**ADDENDUM TO THE
ENVIRONMENTAL IMPACT REPORT
FOR THE
5901 SUNSET PROJECT
(CASE NUMBER: ENV-2013-2813-EIR)**

December 2018

ADDENDUM TO THE ENVIRONMENTAL IMPACT REPORT FOR THE 5901 SUNSET PROJECT

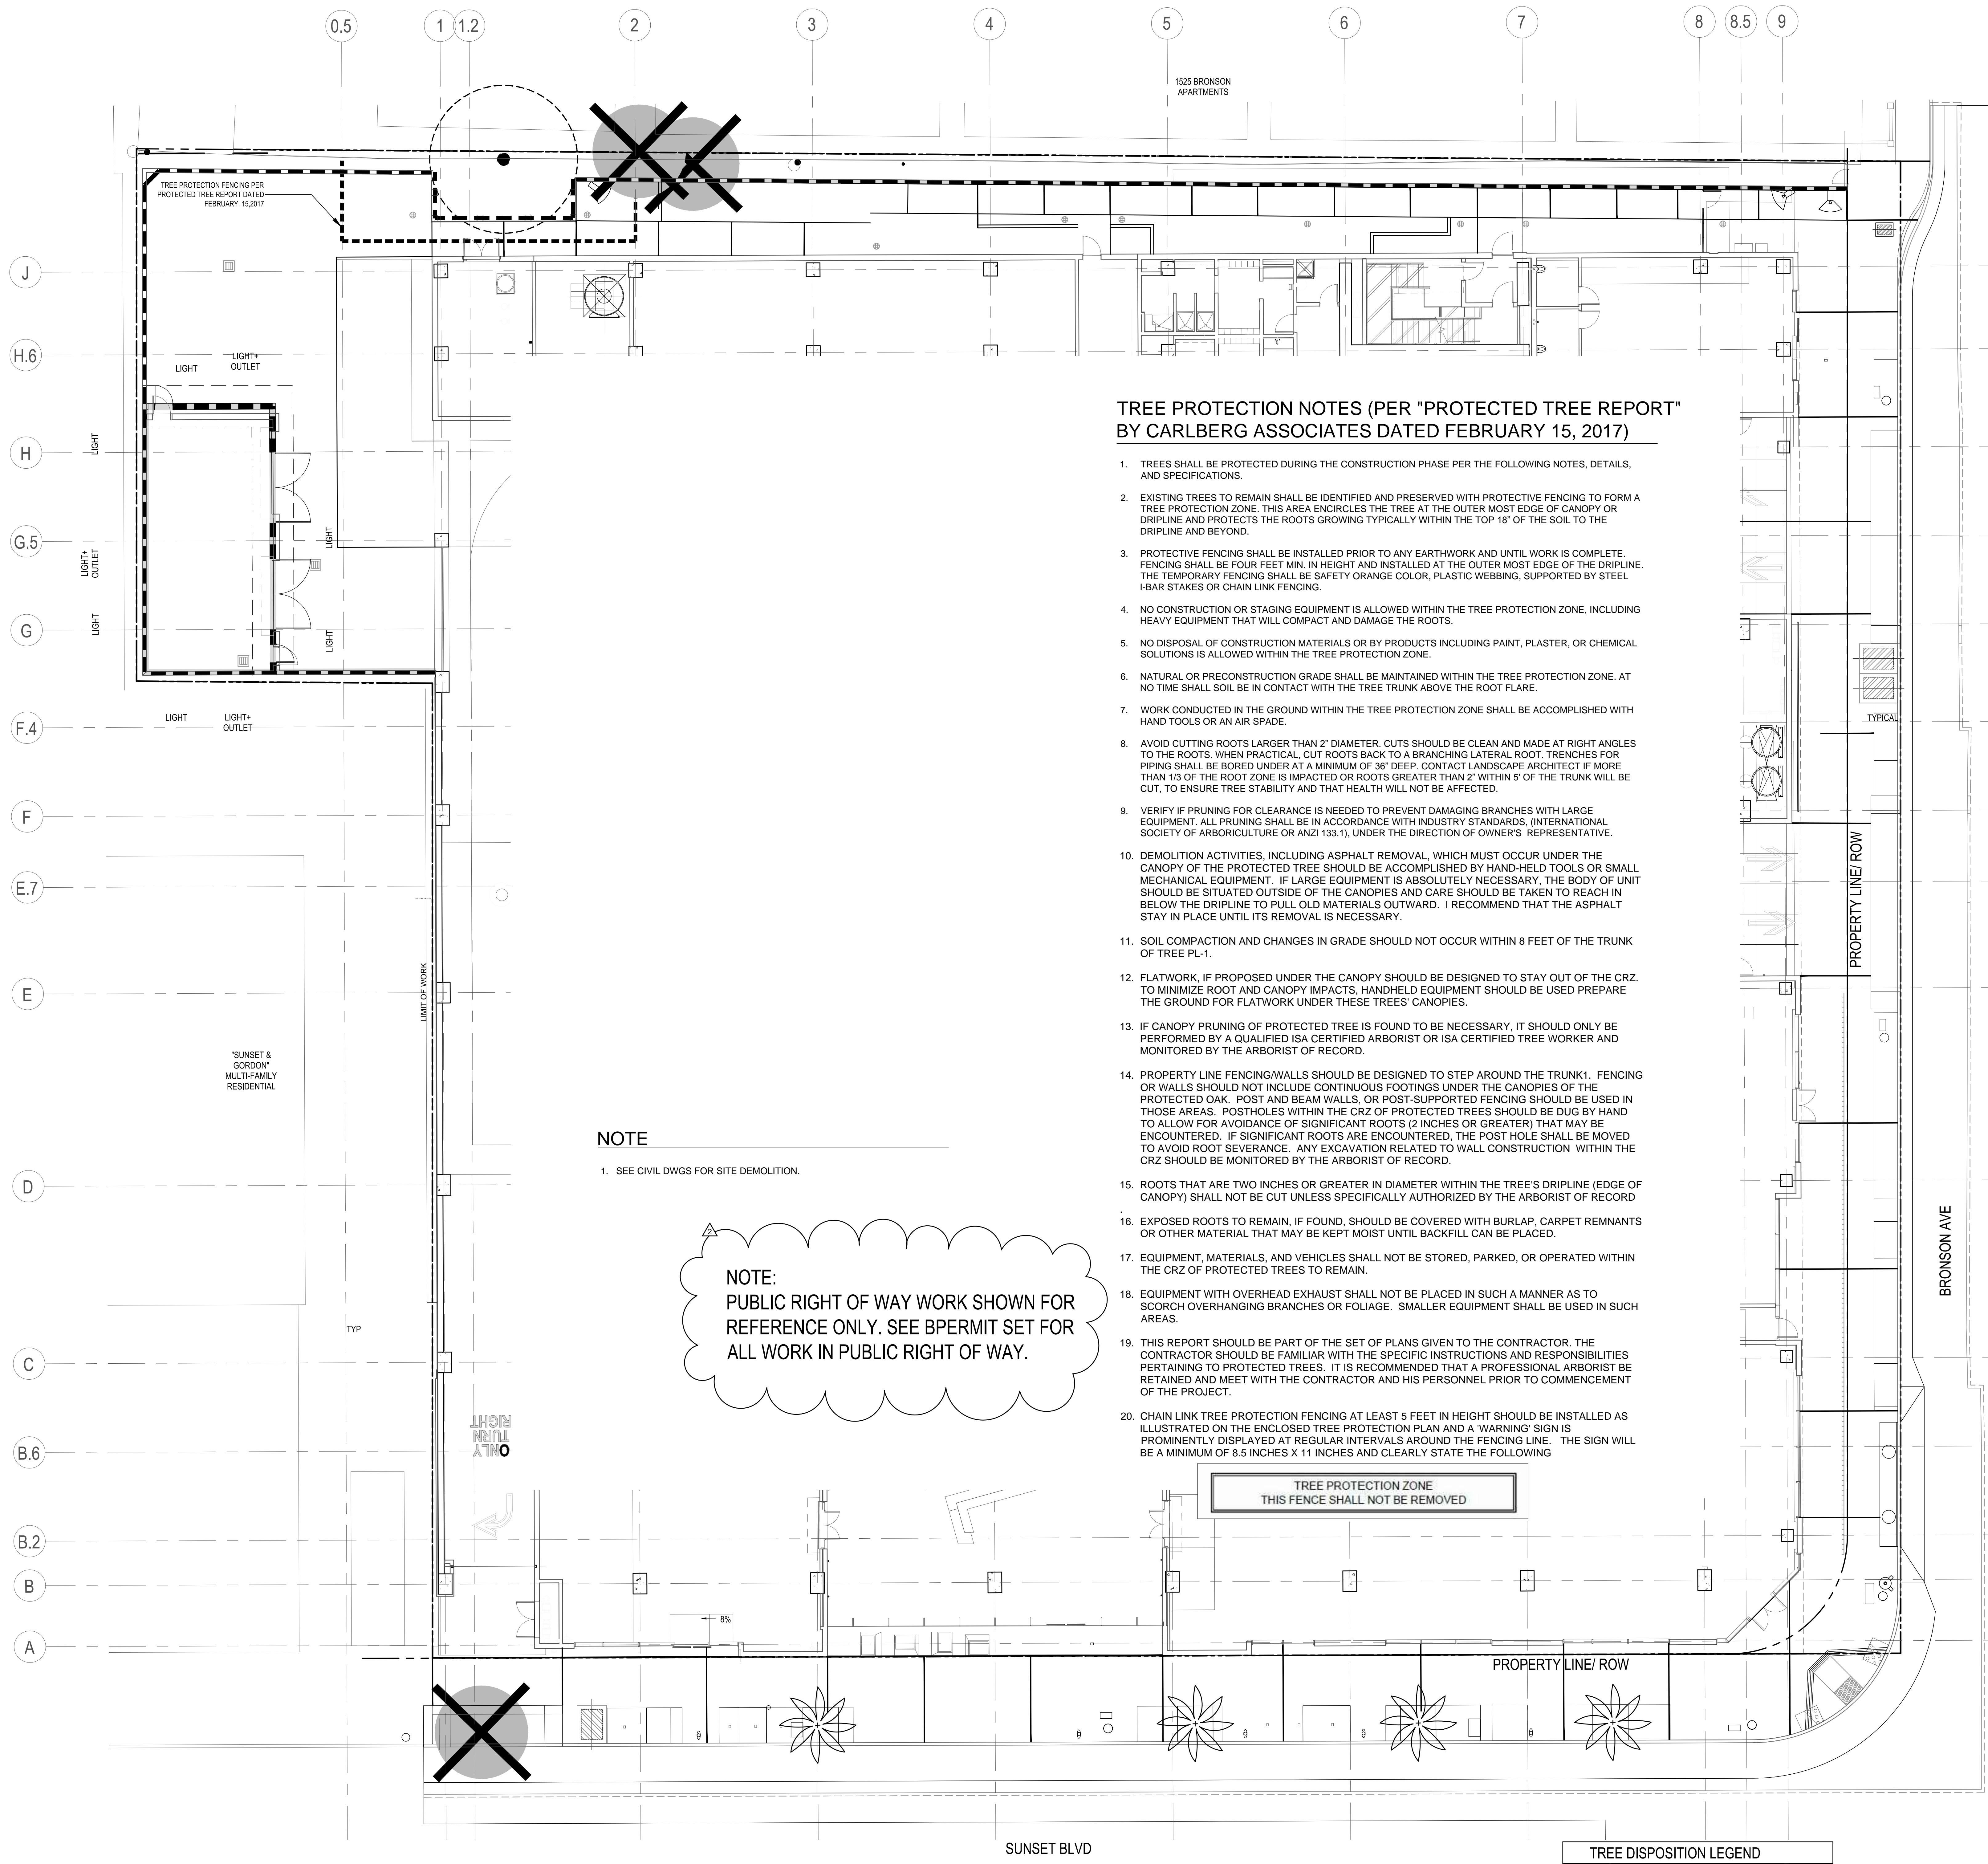
A site plan showing the proposed street tree to be removed is included in Appendix A of this Addendum. This document supplements the information necessary for the proposed approval of a street tree removal permit and does not present new information of substantial importance which would create one or more significant effects not previously disclosed or increase the severity of the significant events already evaluated in the Certified EIR. Changes to mitigation measures or the alternatives analyzed in the Certified EIR also would not occur.

As previously described and as illustrated in Appendix A of this Addendum, a modification to the Approved Project is proposed to allow the removal of one palm tree located along the Sunset Boulevard sidewalk fronting the Project Site. As shown in Appendix A of this Addendum, the palm tree is located midblock along Sunset Boulevard. The removal of this palm tree is necessary to implement the service-only driveway exit on Sunset Boulevard approved as part of the Approved Project.

A Tree Removal Permit will be required from the City of Los Angeles Urban Forestry Division for the proposed removal of one palm tree along Sunset Boulevard. The City of Los Angeles Board of Public Works requires that two 24-inch box-size trees be planted to replace each street tree removed. Therefore, two 24-inch box size trees must be planted to replace the one palm tree proposed for removal. As shown on the Proposed Planting Plan provided in Appendix B of this Addendum, one replacement palm tree and two additional golden rain trees would be planted along Sunset Boulevard. This planting meets the required type and quantity of replacement trees. These tree species are drought-tolerant once established. The irrigation systems would include a dedicated meter and backflow. It is noted that the final tree locations and species and irrigation specifications will ultimately be specified by the landscape architect in consultation with the City of Los Angeles Urban Forestry Division.
